Re: As-Built Baseline Report and Drawings for Hornpipe Branch Tributaries Site
(#100076)

RE: WLS Responses to NCDEQ DMS Review Comments for Task 6 Submittal, Final Baseline Monitoring Report for the Hornpipe Branch Tributaries Mitigation Project, DMS Full-Delivery Project ID #100076, Contract #7605, Neuse River Basin, Cataloging Unit 03020202, Lenoir County, NC

MYO FINAL MONITORING REPORT
Hornpipe Branch Tributaries Mitigation Project
Lenoir County
Neuse River Basin
CU 03020202

FIGURE
1a

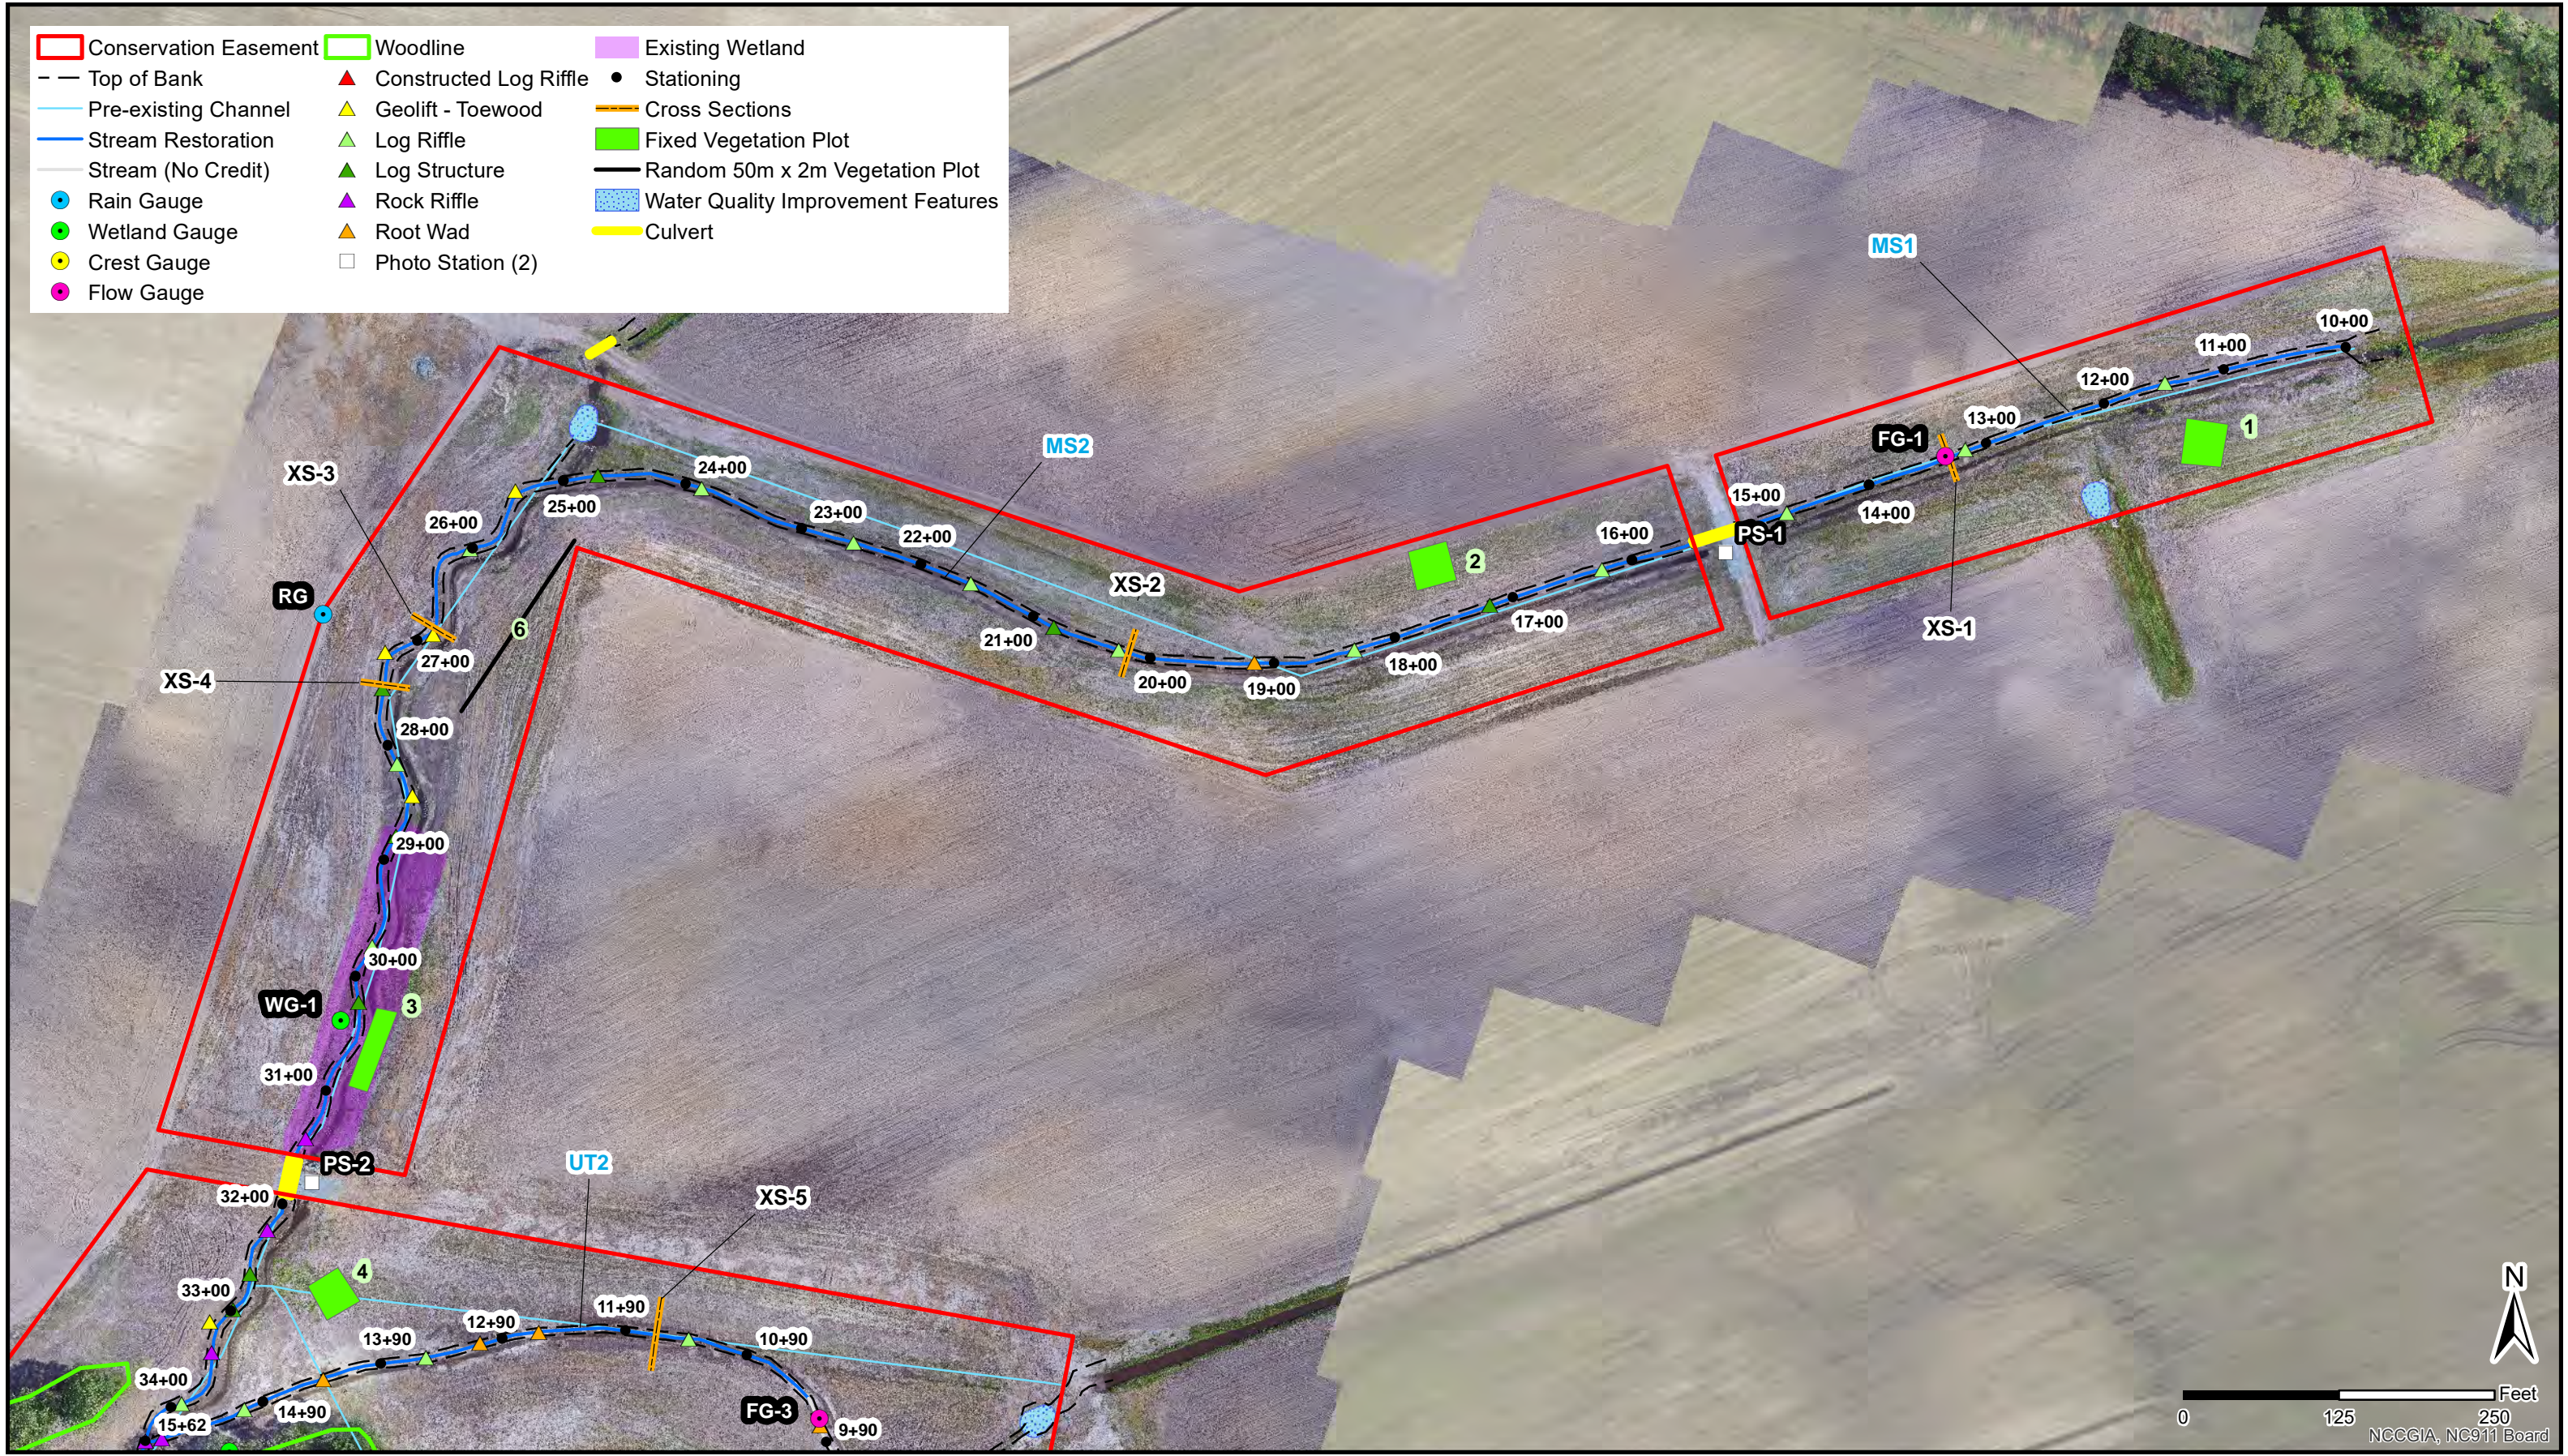
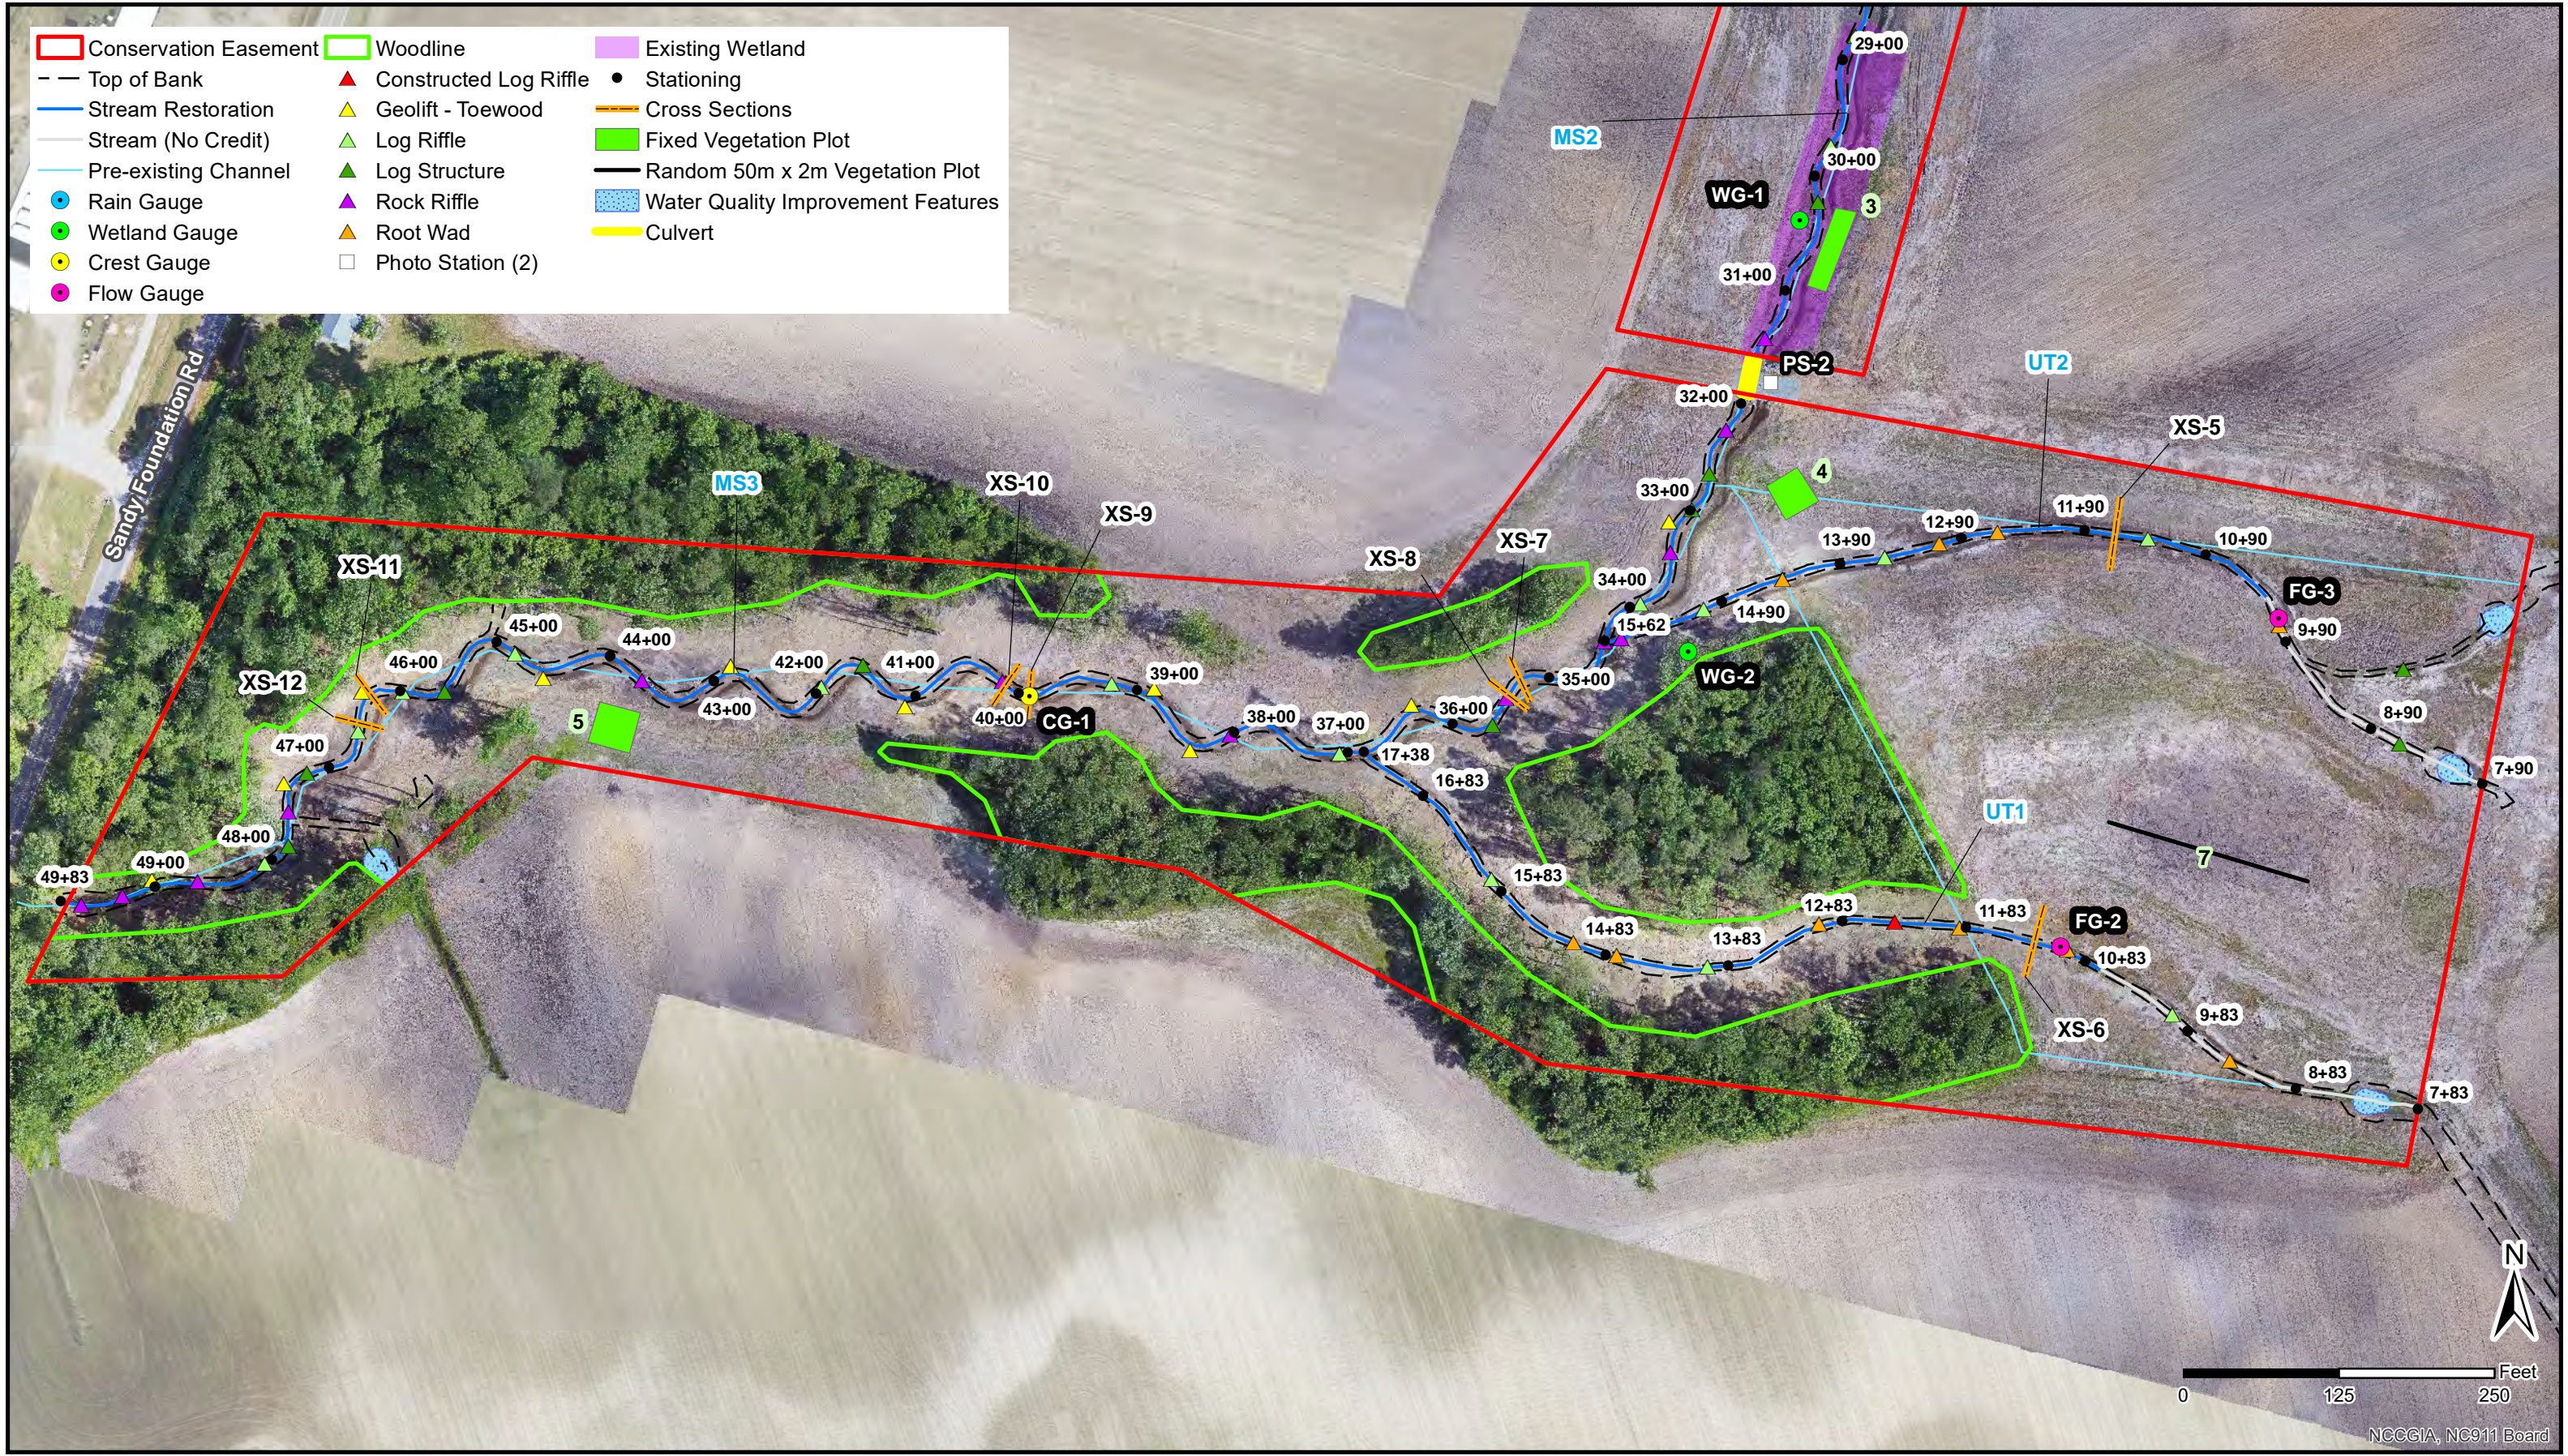
- **It appears that the flow gages on UT1 and UT2 were moved upstream as shown on the CCPV map and that the gauge is above the stated stationing for credit on UT2 (previously 10+62). This is a good installation choice given the DWR expressed concern during plan stages. Please clarify.** Response: Flow gauges on UT1 and UT2 were moved upstream due to lack of appropriate pools for accurate gauge readings. Language was also added to section 4.5.1 in the report document.

- **Consider showing where headwater stream credit starts for UT1 and UT2 on your CCPV.** Response: The stream sections on UT1 and UT2 that are non-creditable have been segmented and are now added to the legend and attribute table, per comment below.
